## T43143

### GM & Fiat 1.6, 1.8 Petrol

There is a small difference between the Gates T43143 tensioner and its OE equivalents (Fiat 55574864 and GM 5636131 or 55570290). Although T43143 has no holes to lock the tensioner with a retaining pin, the procedure outlined below makes belt installation easy.

Fig. 2

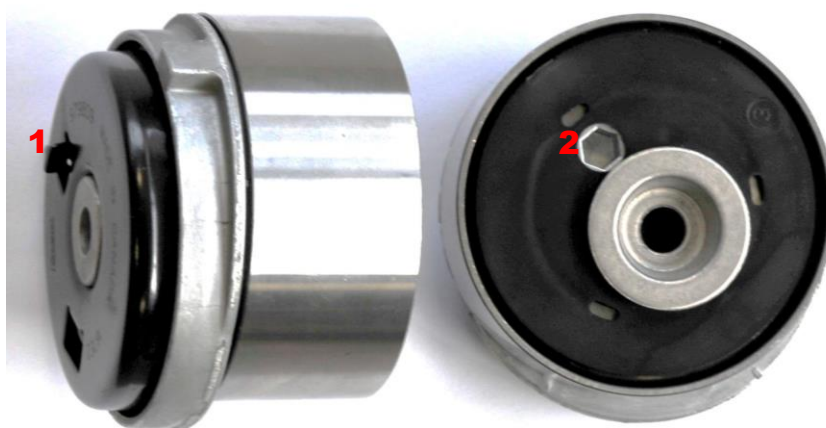
The OE tensioner is preloaded and, therefore, needs a retaining pin (seen from the back of the tensioner). By following the steps above, the spring inside the Gates tensioner has been loaded (blue arrow in Fig. 3)

1 - Put the tensioner in place: locating lug (1 in Fig.2) correctly positioned.

2 - Torque the installation bolt to 25 Nm, while holding the tensioner in place with a 6 mm Allen Key (2 in Fig. 2).

3 - Install the belt over the tensioner pulley by rotating the tensioner clockwise to the stop, using the same Allen key.

4 - Gradually release the tensioner towards the belt.
